**RED MILL ROAD WATER TREATMENT PLANT
CONTRACT DPW-2022-05**

ADDENDUM NO. 2

October 25, 2021

E-27

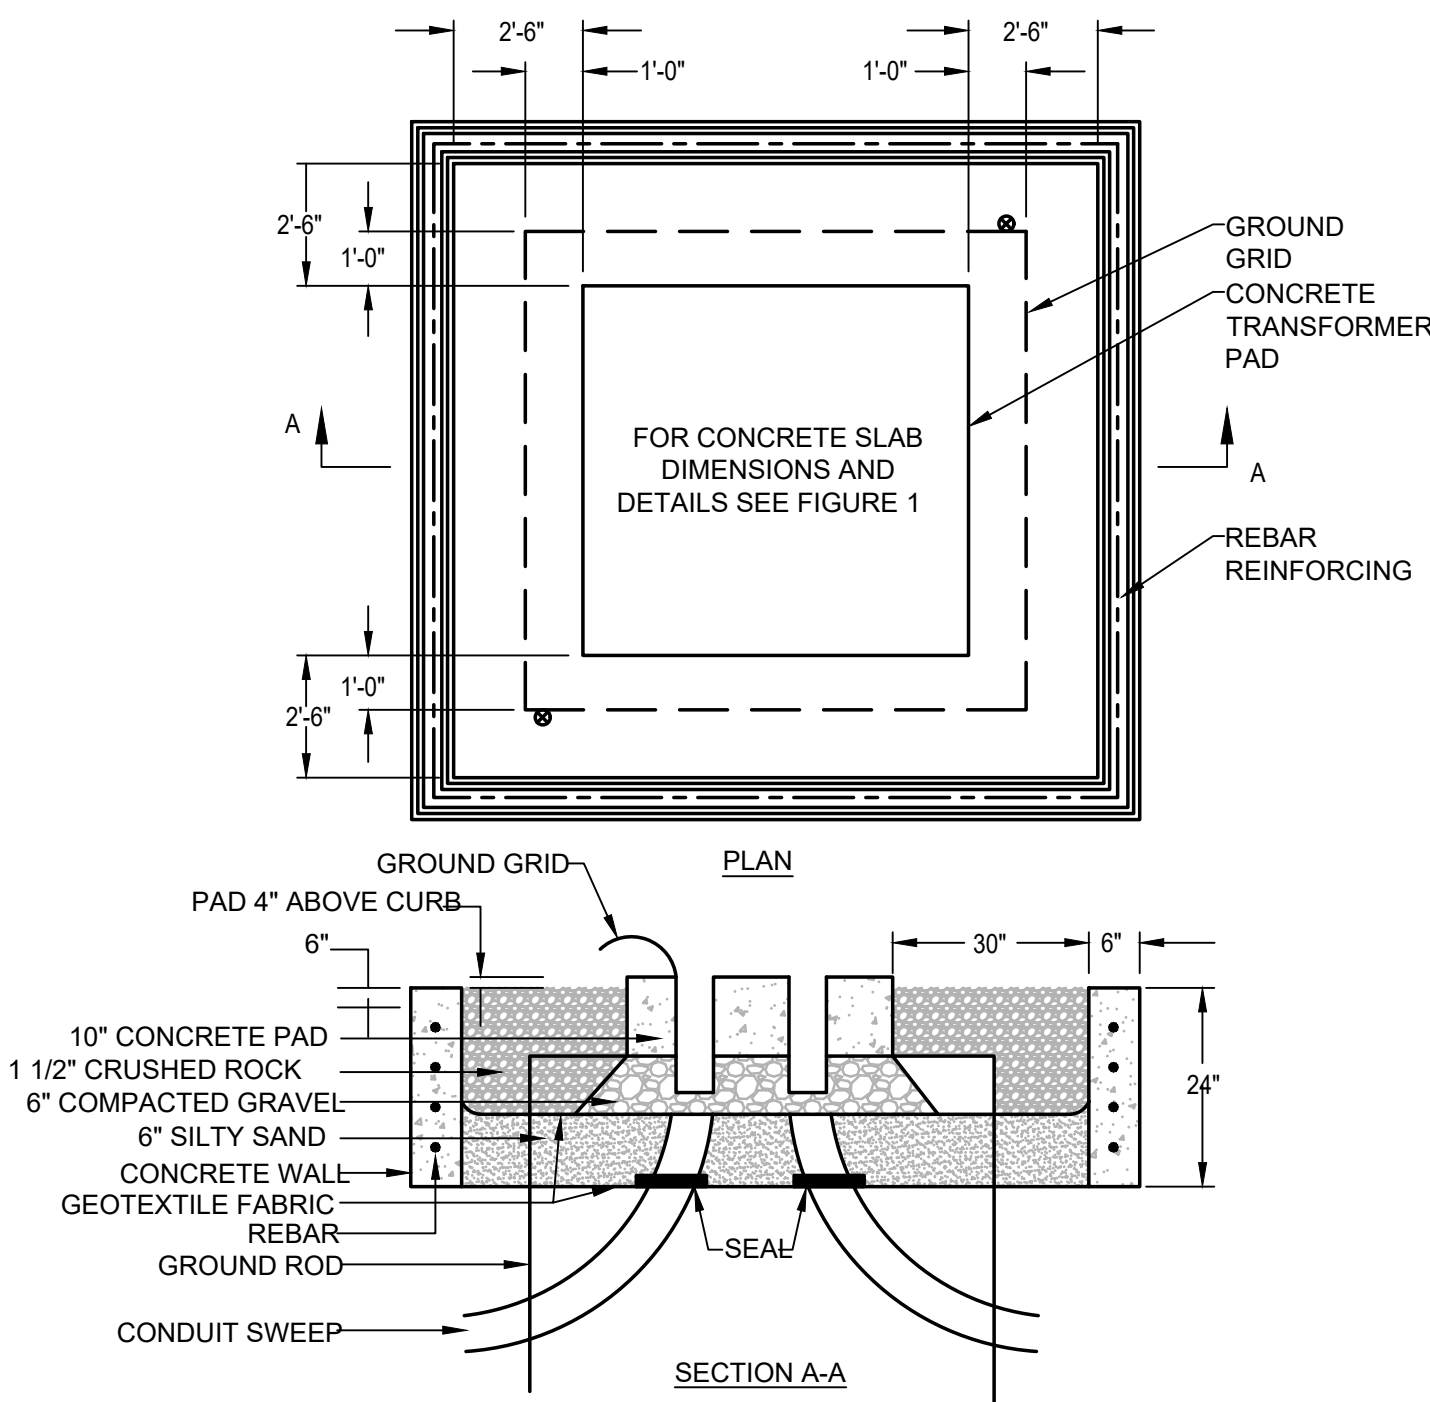
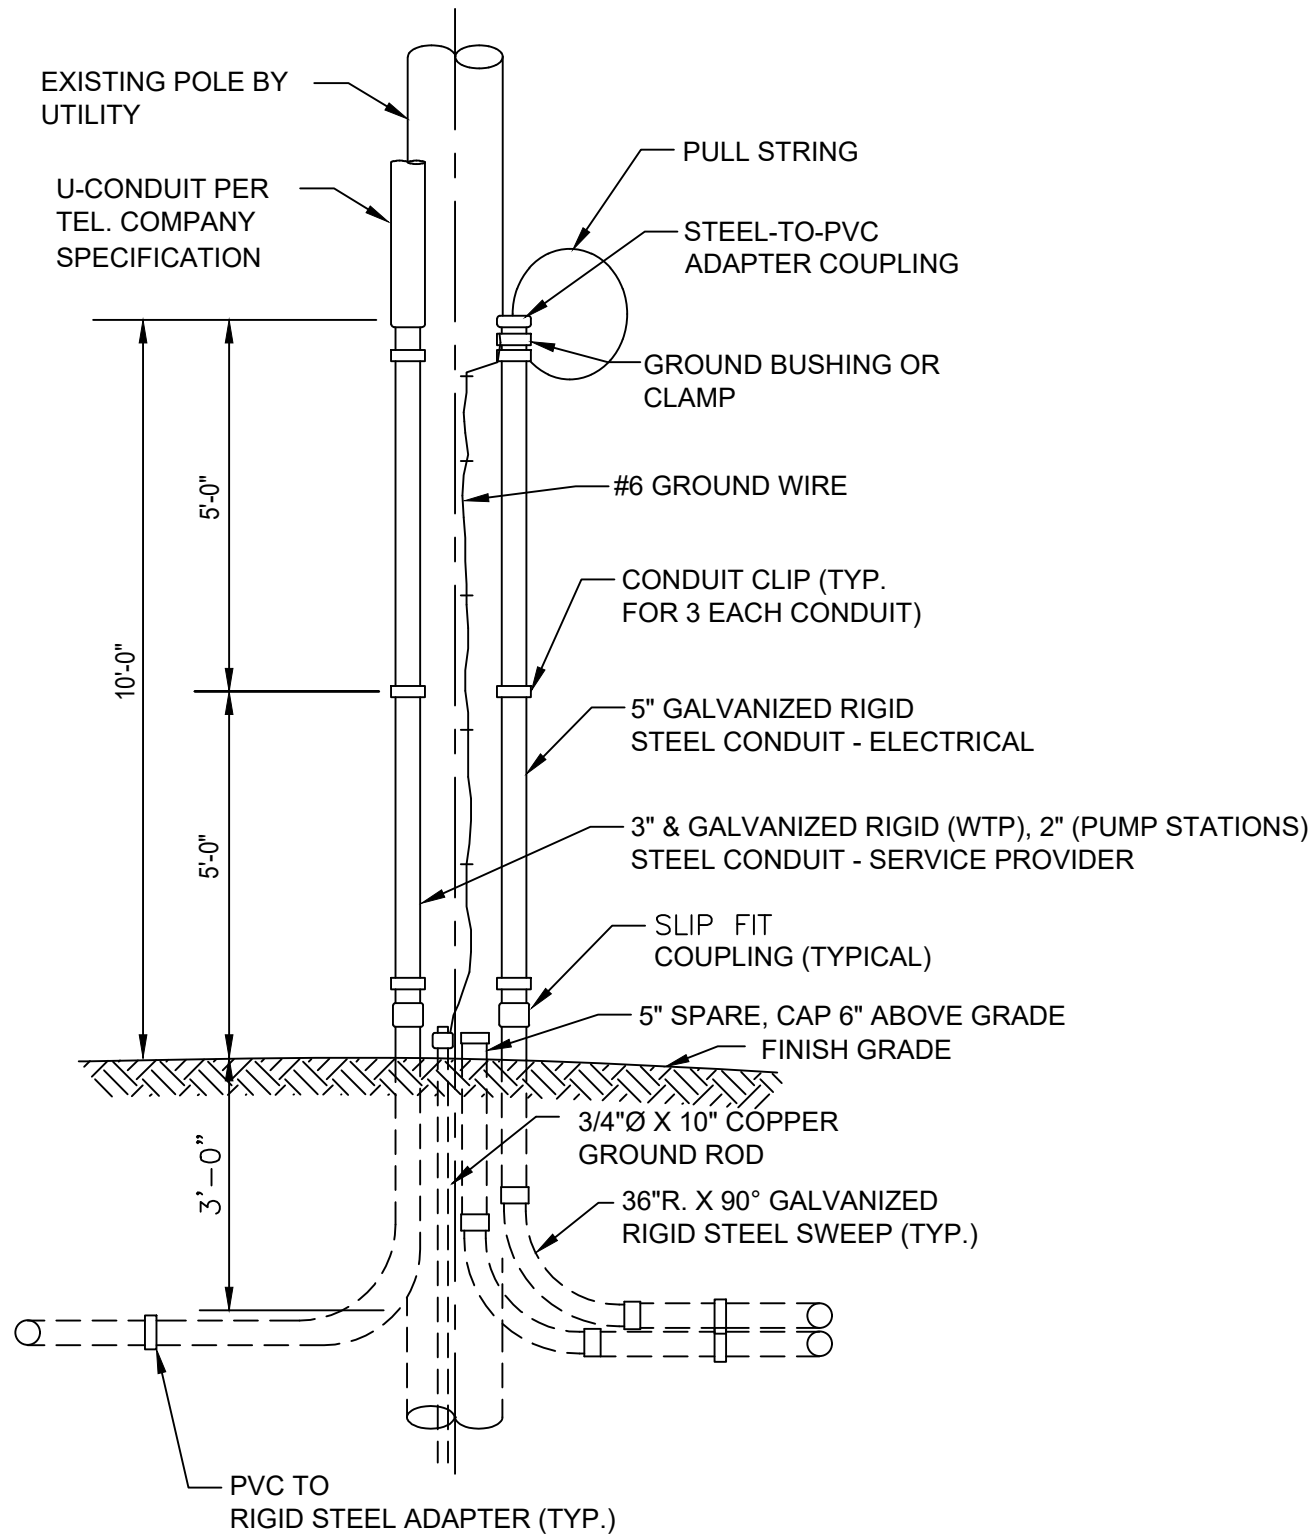
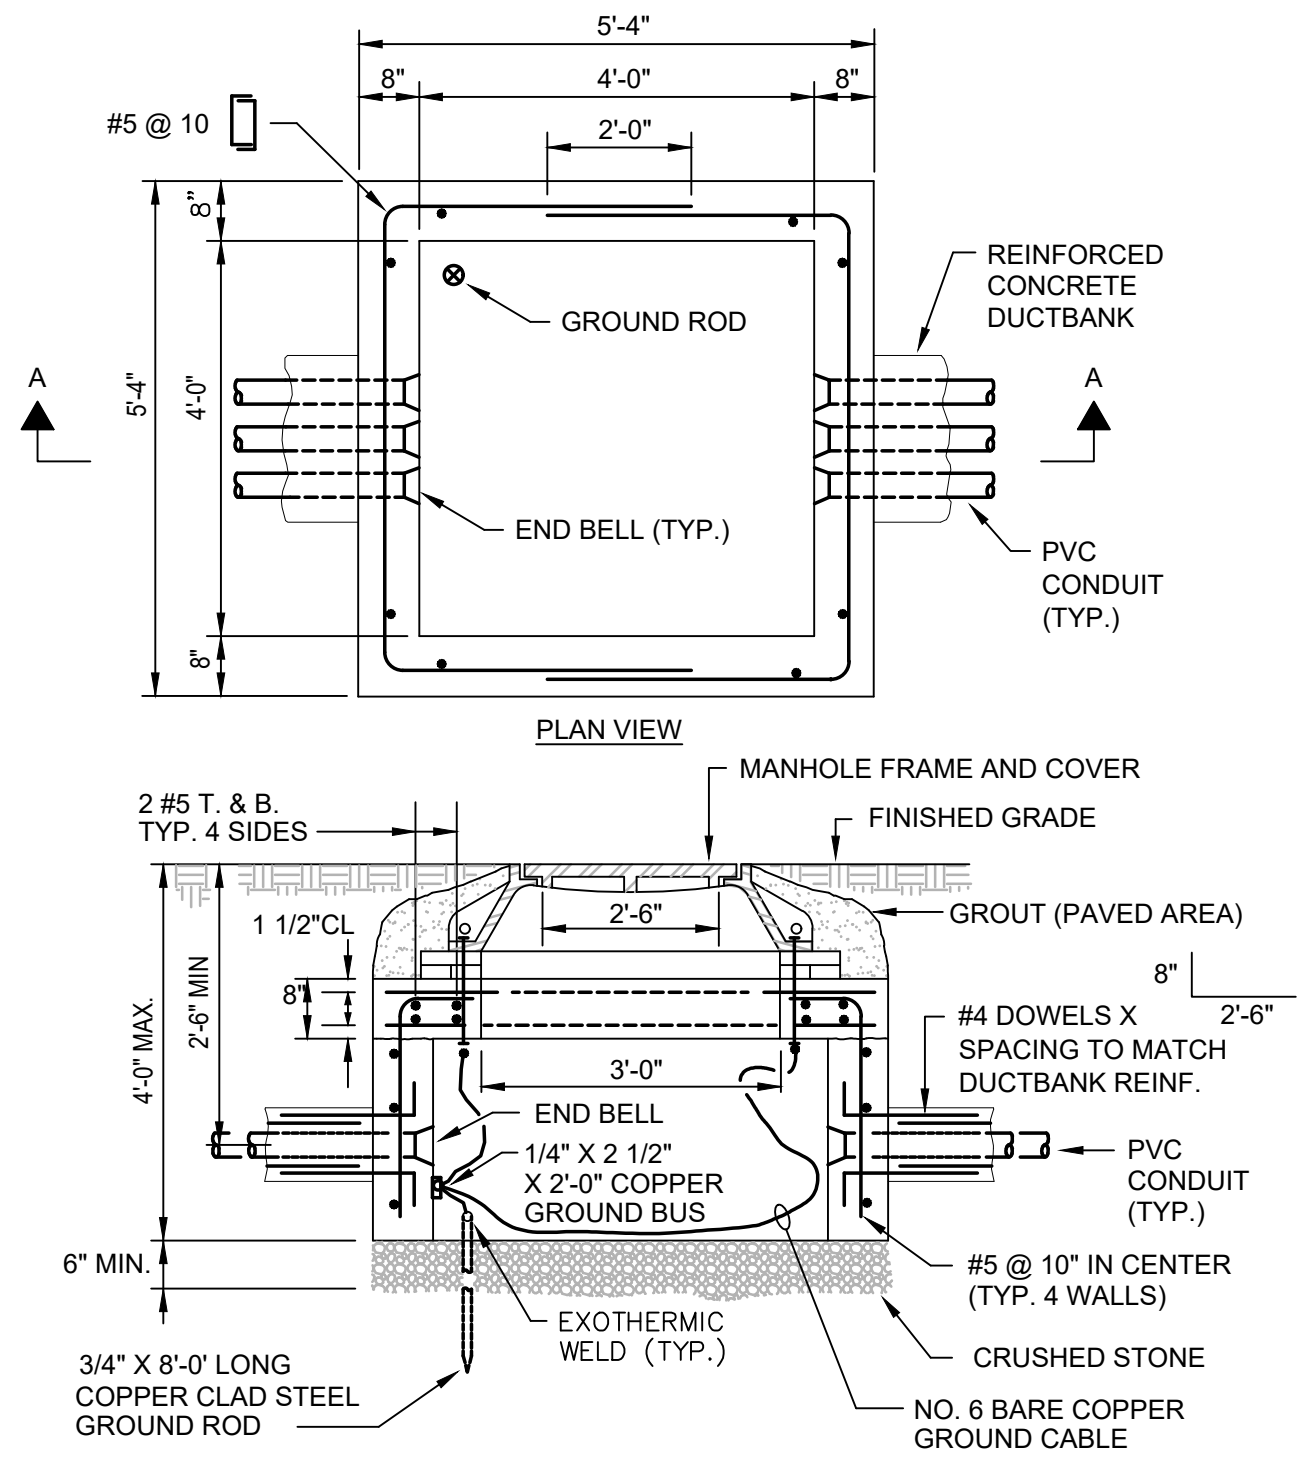
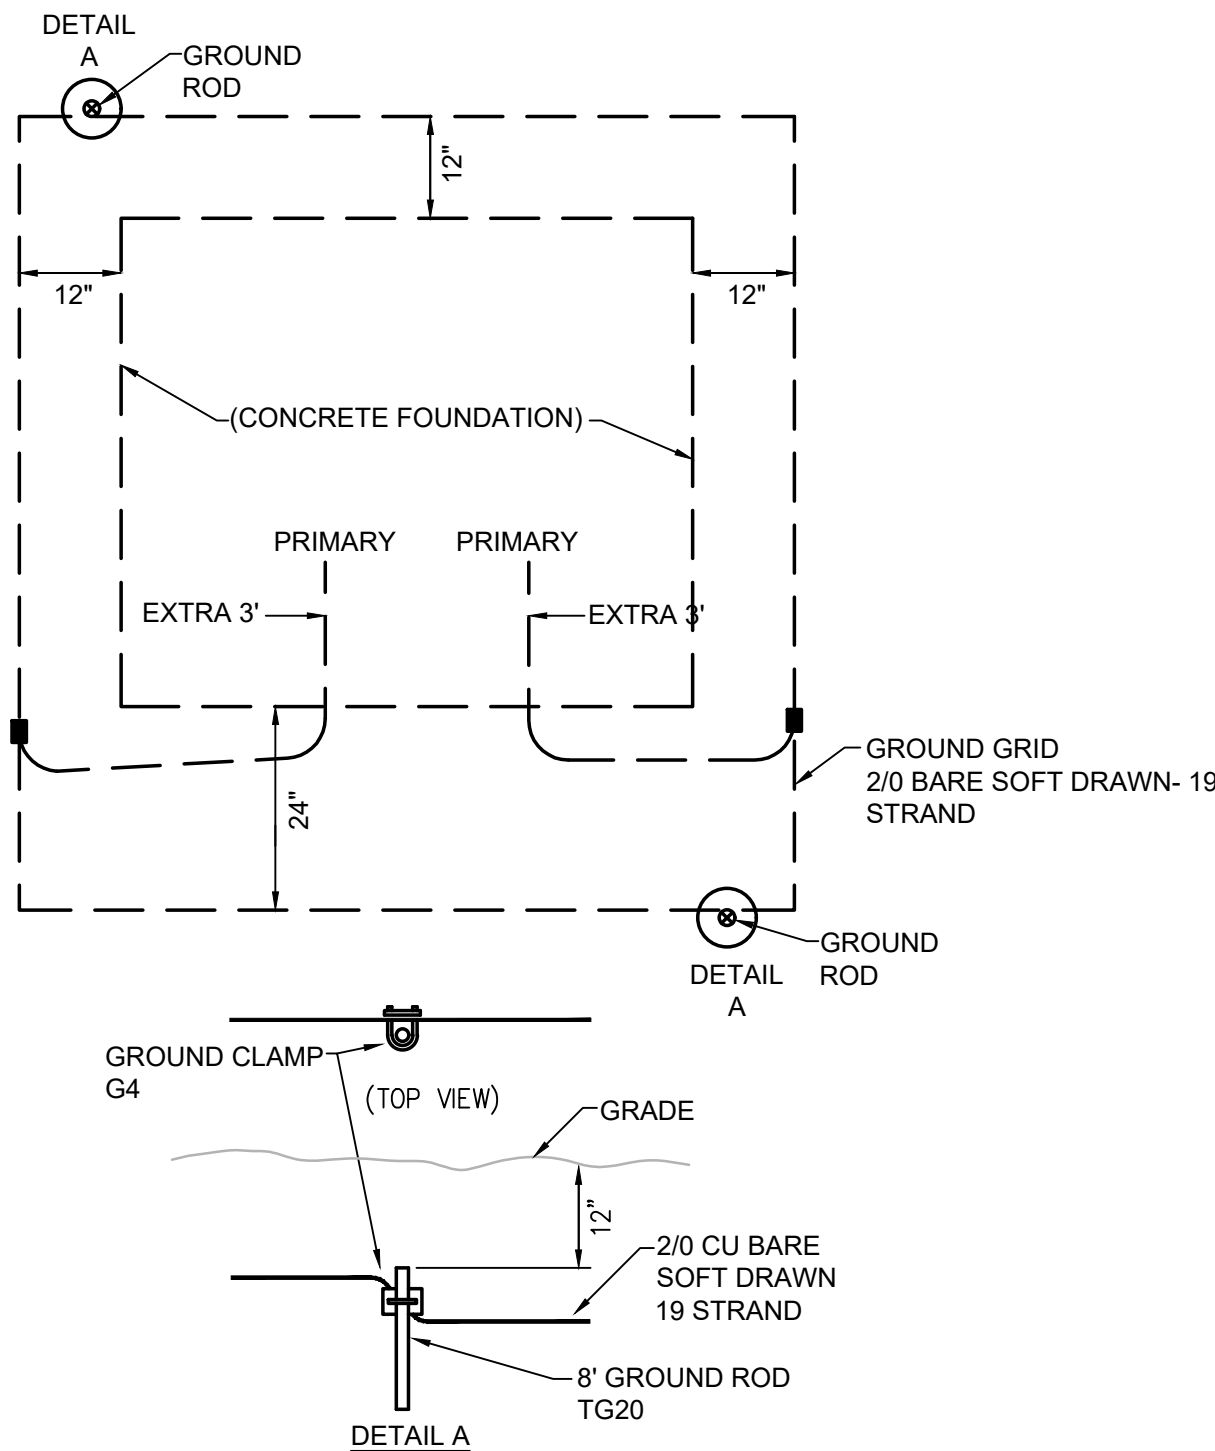
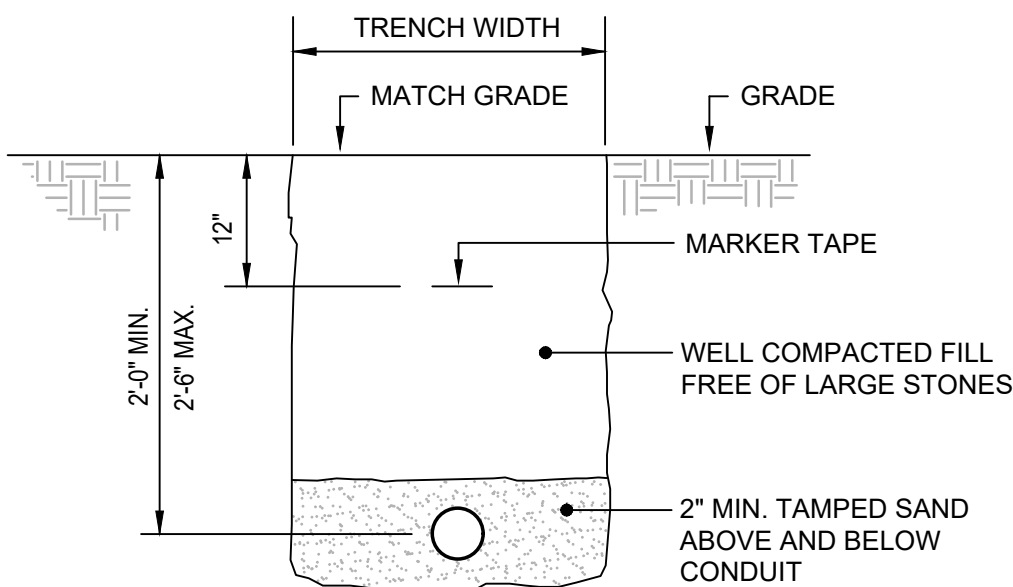
- Under Paragraph 1.13 add the following:
“K. General Contractor shall coordinate with National Grid (NGRID) prior to any electrical trenching. General Contractor shall coordinate with NGRID for GRID to inspect the riser, encased conduit, heavy duty handhole, and transformer pad.”

- Add Note 12:
“12. General Contractor shall coordinate with National Grid (NGRID) prior to any electrical trenching. General Contractor shall coordinate with NGRID for GRID to inspect the riser, encased conduit, heavy duty handhole, and transformer pad.”

Attachment 2 – Revised Contract Drawings (Sheets E-3 and E-27)

ADDENDUM NO. 2: ADD DETAIL 10 / A-13 DESIGNATION AT COLUMN LOCATION C-1 ON SHEET A-1.

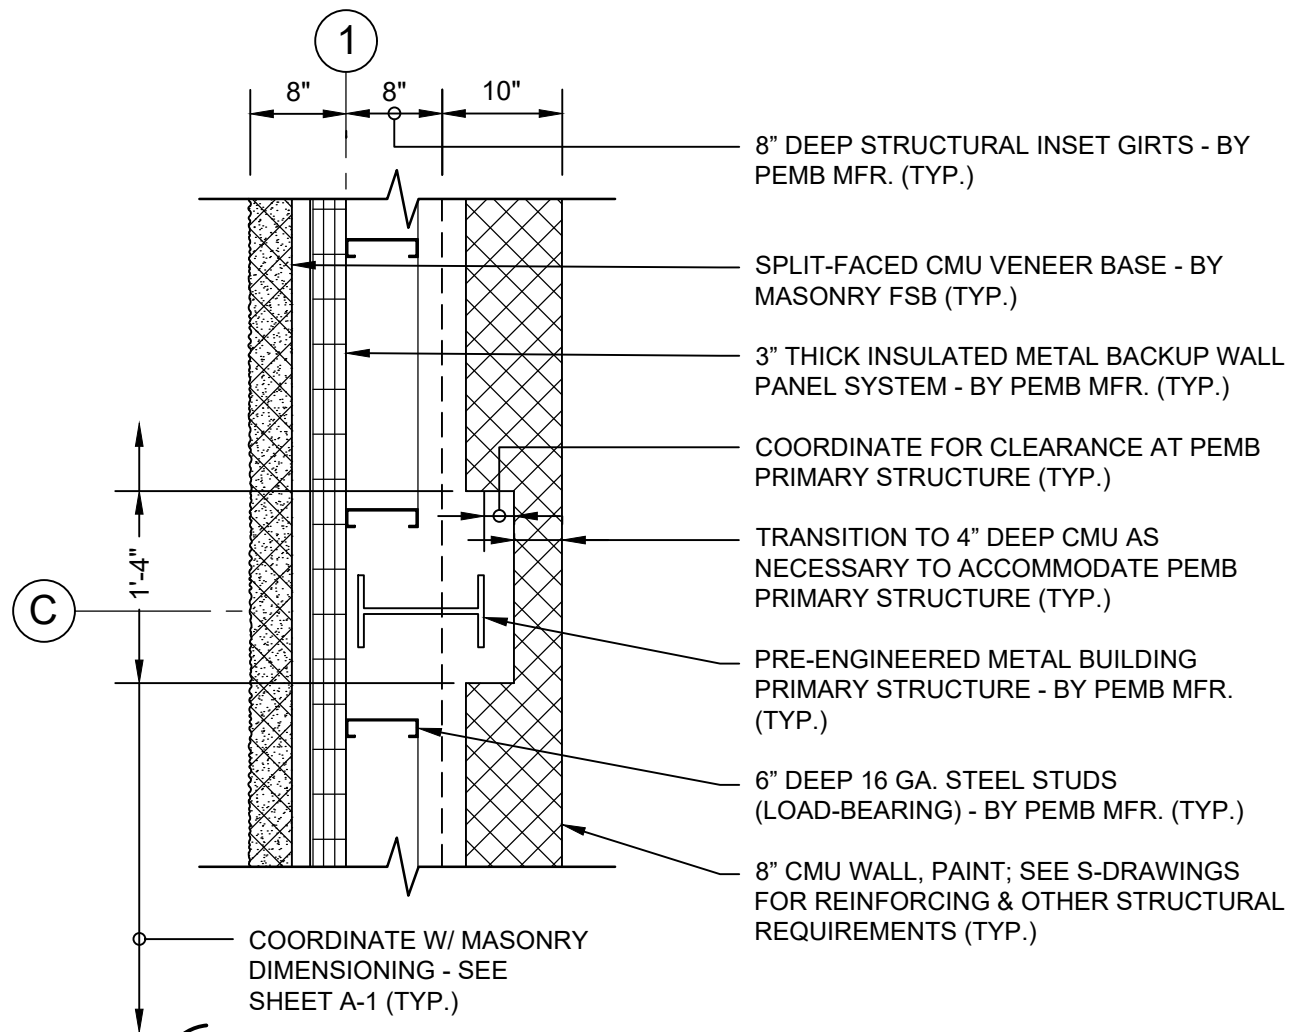
Question 5: Please reference drawings A-1, S-1, and section 12 on S-5. On the plan view drawings, it appears that the structural steel columns at grid intersections B-1 and C-1 will interfere with the CMU wall and will require a 'box out' of some kind around the steel. Section 12 on S-5 appears to show the steel columns starting outside of the wall, but growing in size to eventually intersect the wall at some height. Please confirm at what height the steel will intersect the wall and a 'box out' will be needed. Also, please provide a detail on what this 'box out' should involve, such as 4" CMU block run in place of 8".

NOTE: CONDITIONS APPLY SIMILARLY AT COLUMN LOCATIONS A1, B1, & D1.

INTERIOR CMU WALL AREAS:

Answer 5: Refer to Attachment 3.

ADDENDUM NO. 2: ADD DETAIL 11 / A-13
DESIGNATION AT COLUMN LOCATION
A-2 ON SHEET A-1.

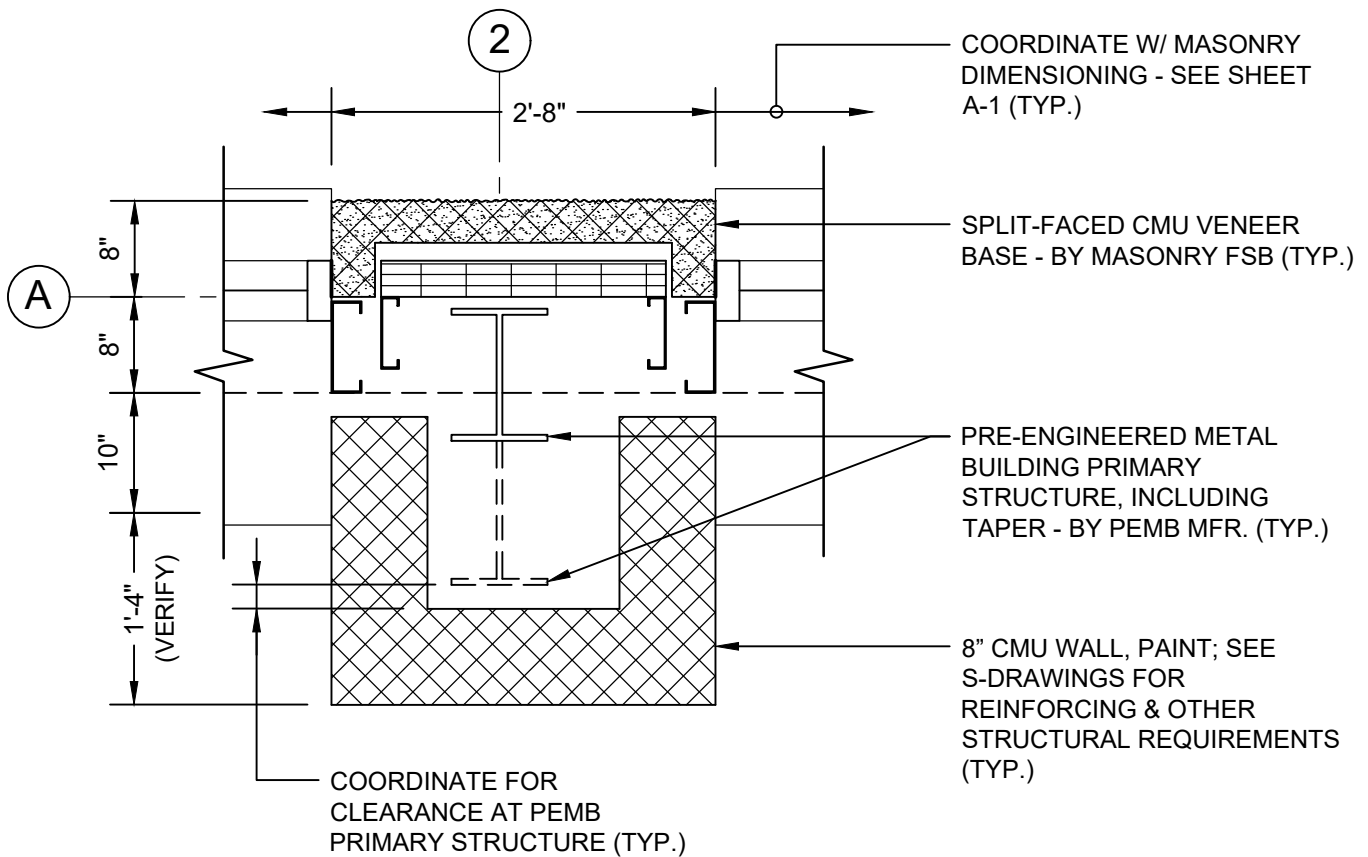
NOTE: CONDITIONS APPLY SIMILARLY AT COLUMN LOCATION D2.

INTERIOR CMU WALL AREAS:

ADDENDUM NO. 2: ADD DETAIL 11 TO SHEET A-13.
